UNITED STATES PATENT AND TRADEMARK OFFICE

10/542,374

Office Action Summary

DETAILED ACTION

Fig. 1

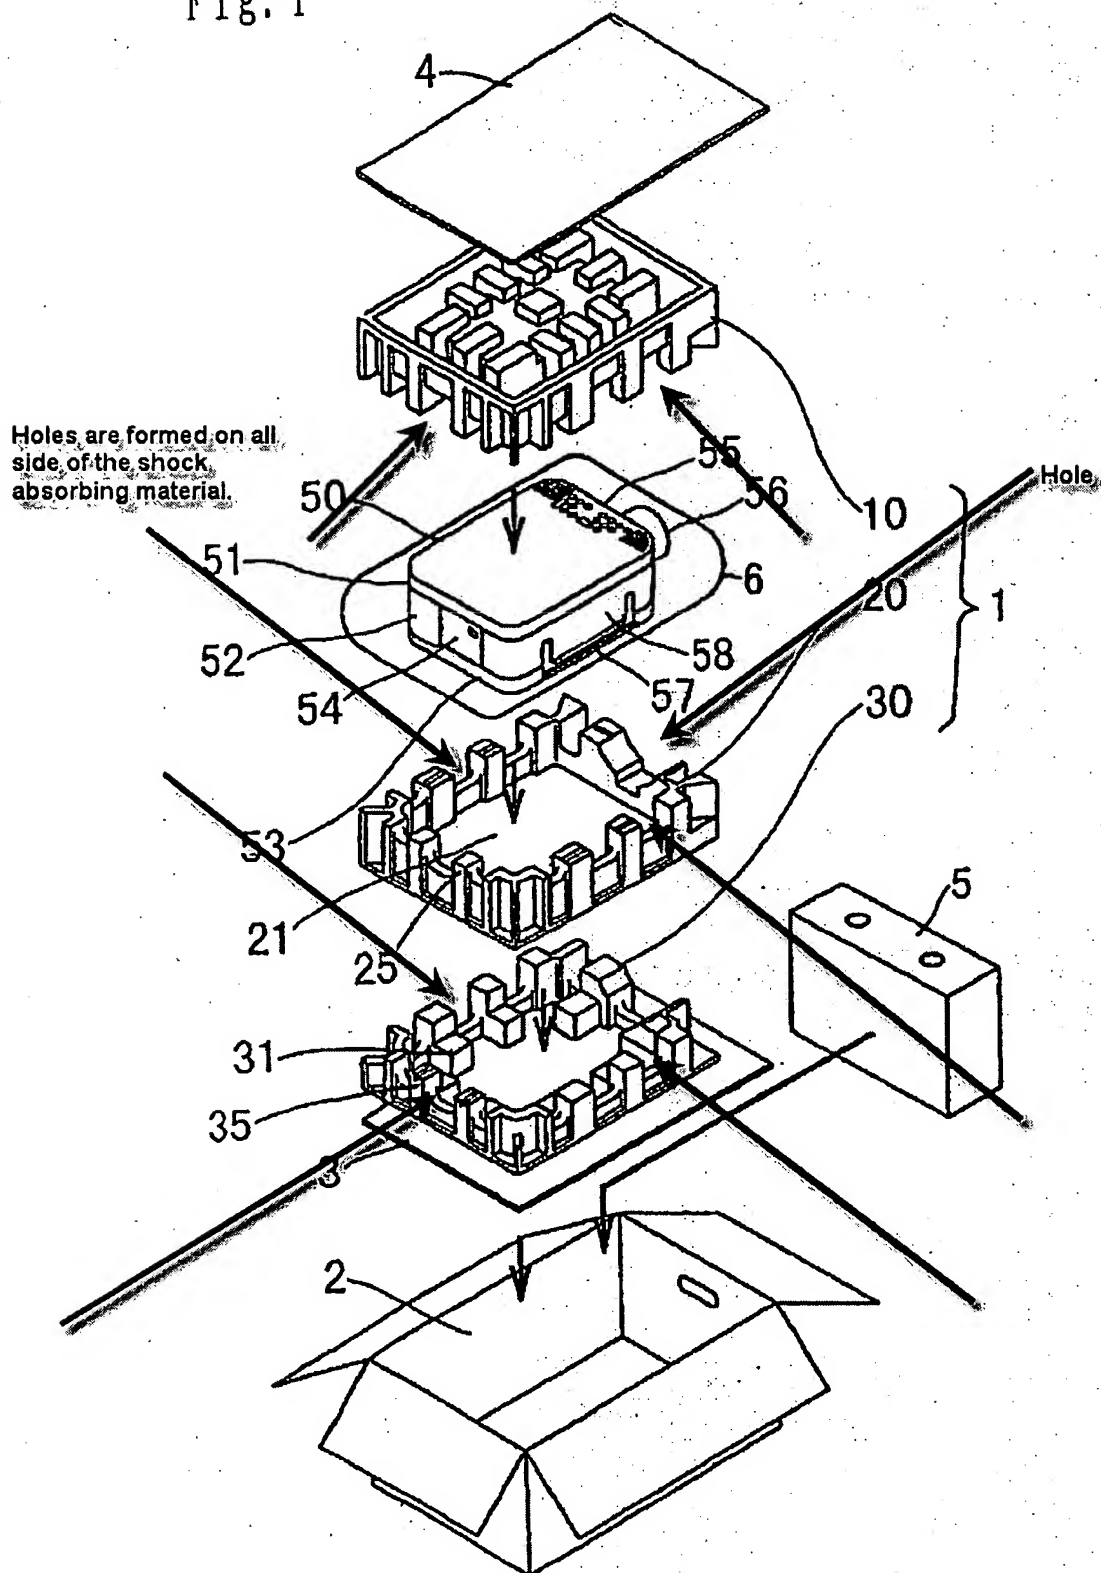
7. In response to the Applicant's argument that: "The alleged hole formed between the hollow projections 15 and 25, however, does not penetrate a single pad, as recited in claim 1, but is merely "formed" when two pads enclose the article 50", this is not found persuasive for the following reason:

Accordingly, the examiner maintains that figures 1-8 of Koike clearly show that holes are formed on all sides of the shock absorbing material. For example, figure 1 shows opening spaces between projections, on all sides, of each of shock absorbing materials (10, 20, 30).

Attached is the copy of Fig. 1 of Koike reference, and the arrows provided pointing to the openings (or holes) on all side of the shock absorbing materials (10, 20, 30), and each shock absorbing material is a single pad.
